Final Environmental Impact Statement (FEIS)

BRITAIN WOODS RESIDENTIAL DEVELOPMENT

Little Britain Road
City/Town of Newburgh, Orange, New York
SEQRA Type 1 Action

Date of Submission: February 13, 2026

Little Britain Road – Daily Volume 2024

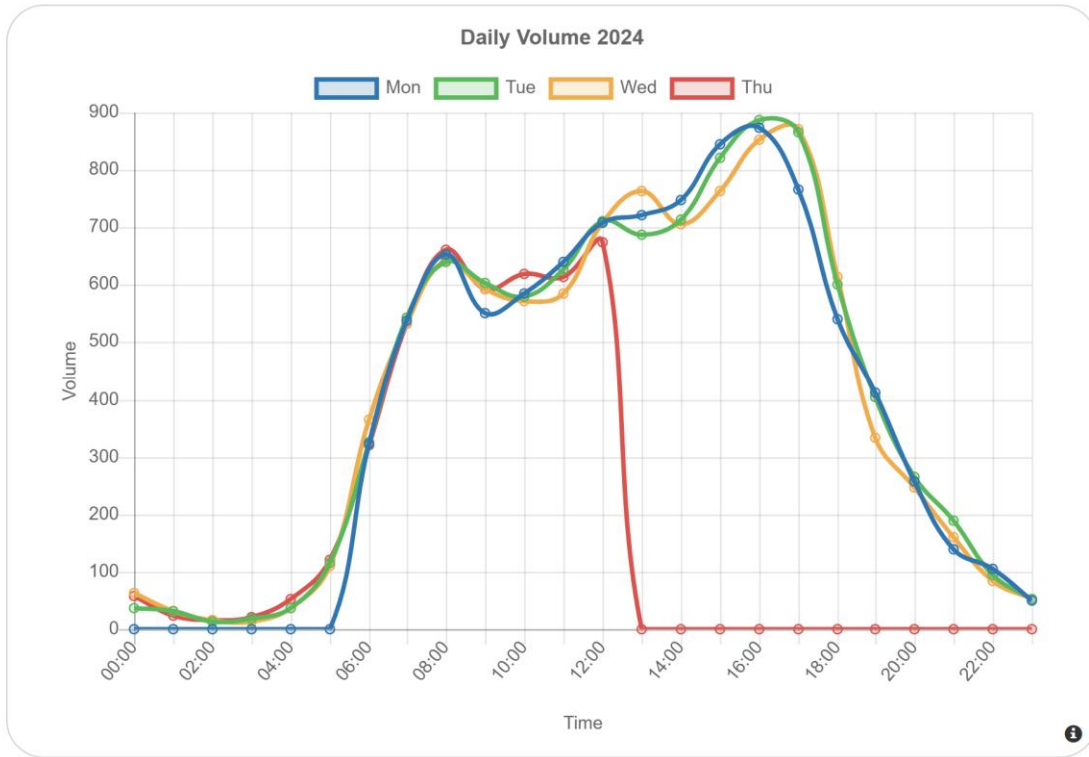
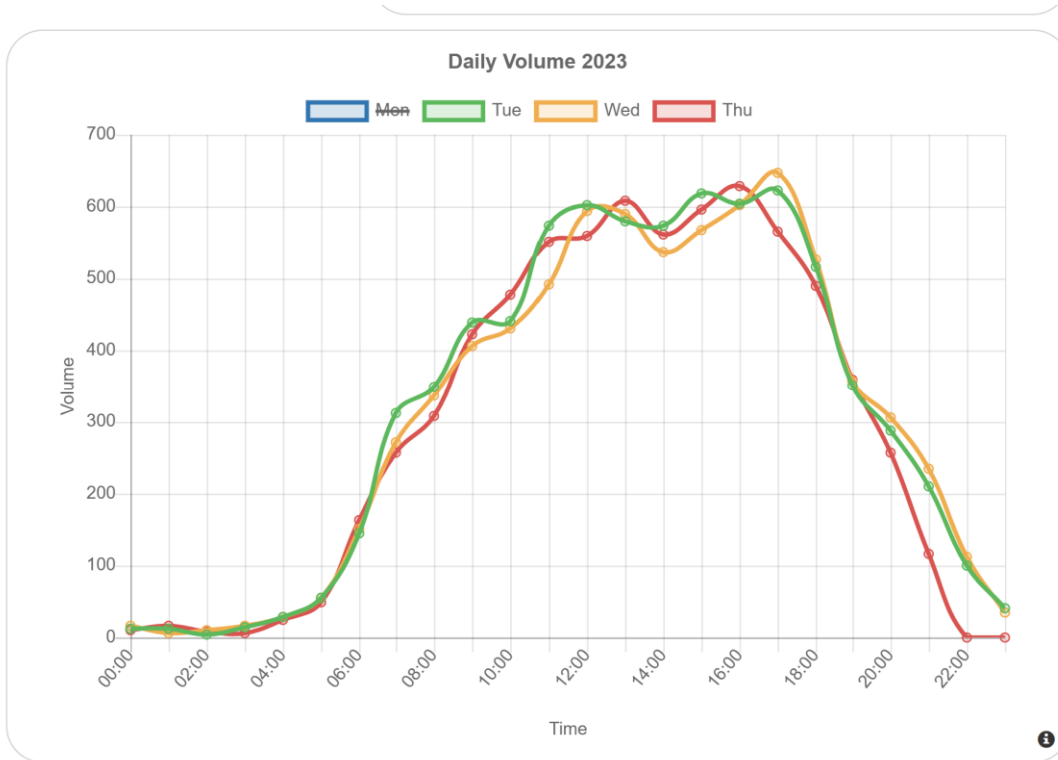
Response 4.3.94:

A review of recent NYSDOT ATR data verifies the original peak hours used in the analysis. See graph below which has graphed the daily volume experienced by NY 207 from Monday September 16, 2024, through Thursday September 19, 2024. It should be noted that Thursday was a partial count. The commuter peak hours are what are to be analyzed for a residential development.

FMO-23-21285 MAP

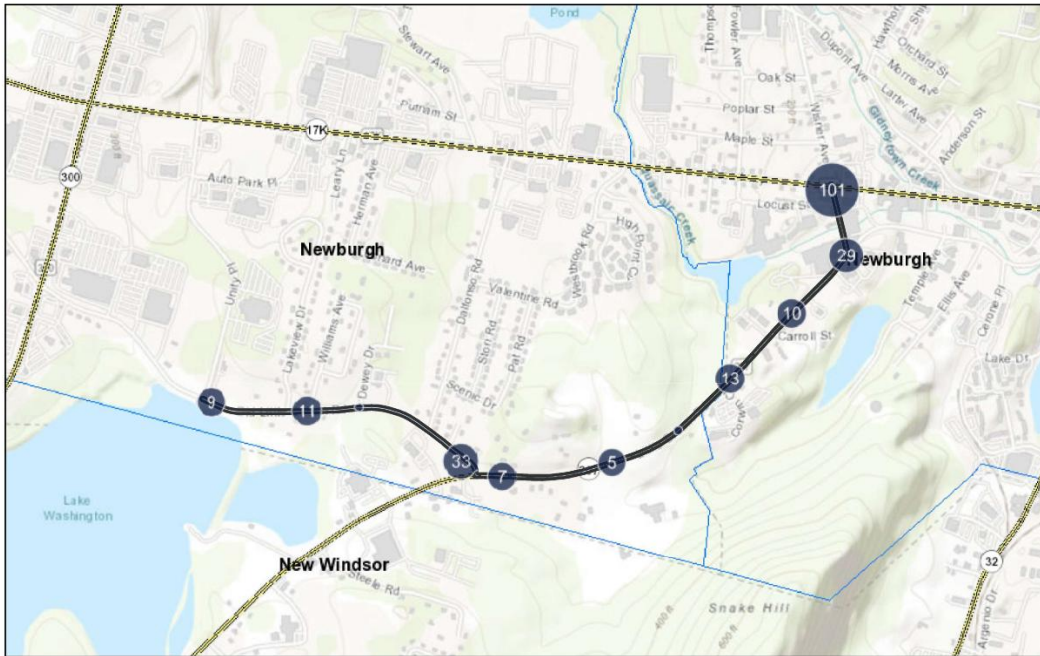
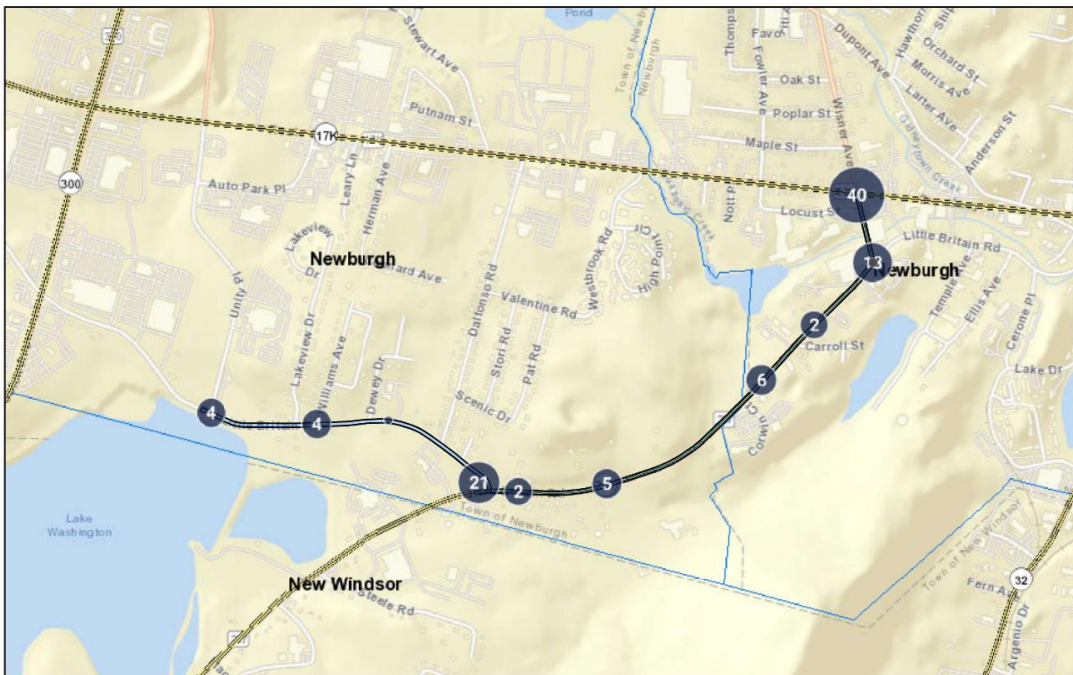
*Please note there is some overlap between the two crash queries thus, some of these crashes are being counted more than once.

- ii. See maps obtained from NYSDOT below:
Date Range: From 8/02/2015 through 7/29/2022.
